### *Consultation on the revision of the TSI relating to accessibility for persons with disabilities and persons with reduced mobility*

## 2. Table of the change requests received and ERA answers

Figure 7 — Examples of minimum doorway position markings (without entrance steps)

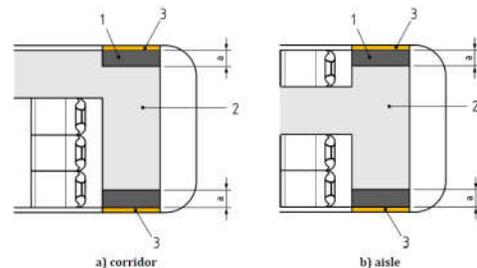
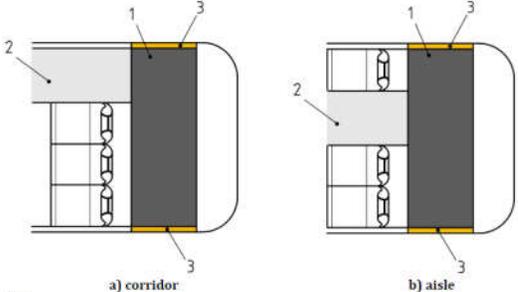
4.2.2.11.2 & 4.2.2.12.1 & 5.3.2.8 & 6.2.3.2	P	Faiveley	<p>Clause 4.2.2.11.2 (4) states that the “As a minimum the first and the last steps shall be indicated by a contrasting band with a depth of 45 mm to 55 mm extending a minimum of 80 % of the width of the steps on the top surface of the step nosing. A similar band shall indicate the front surface of the last step when entering the unit.”</p> <p>Nevertheless clause 4.2.2.11.2 (6) states that “If a step board is fitted and it is an extension of a door sill outside the vehicle, and there is no change in level between the step board and the floor of the vehicle, this shall not be considered to be a step for the purposes of this specification. A minimal drop in level, with a maximum of 60 mm, between the floor surface at door sill and that of the exterior of the vehicle, used to guide and seal the door is also permissible and shall not be considered as a step.”</p> <p>That means that sub-clause (4) related to contrasting band does not apply and that contrasting band are not required.</p> <p>Clause 4.2.2.12.1 - Movable step and bridging plate – does not require contrasting band and refers to clause 5.3.2.8 for additional requirements. Clause 5.3.2.8 - Boarding aids: movable steps and bridging plates – does not require contrasting band on movable steps and bridging plates The conclusion of these clauses is that contrasting bands are not mandatory in case the vestibule and the door sill are at the same level and that</p>	Accepted	We propose to add a reference to EN16584-1 point 5.3.9 in the application guide

contrasting band are not mandatory for movable steps and bridging plates.

Clause 6.2.3.2 – Step position for vehicle access and egress – which states that the “outer end of the floor at the passenger access shall be considered as a step” does not solve the problem because this requirement is clearly only valid to calculate the gap between the vehicle and the platform.

To clarify the requirements, our proposal is:  
 Clause 4.2.2.11.2 – add in sub-clause (4)  
 “The outer end of the floor at the passenger access shall be considered as a step for the purpose of this clause.

Movable steps and bridging plates shall be considered as a step for the purpose of this clause”

Note : see figures 7 and 8 of EN16584-1 below for a better understanding of the comment
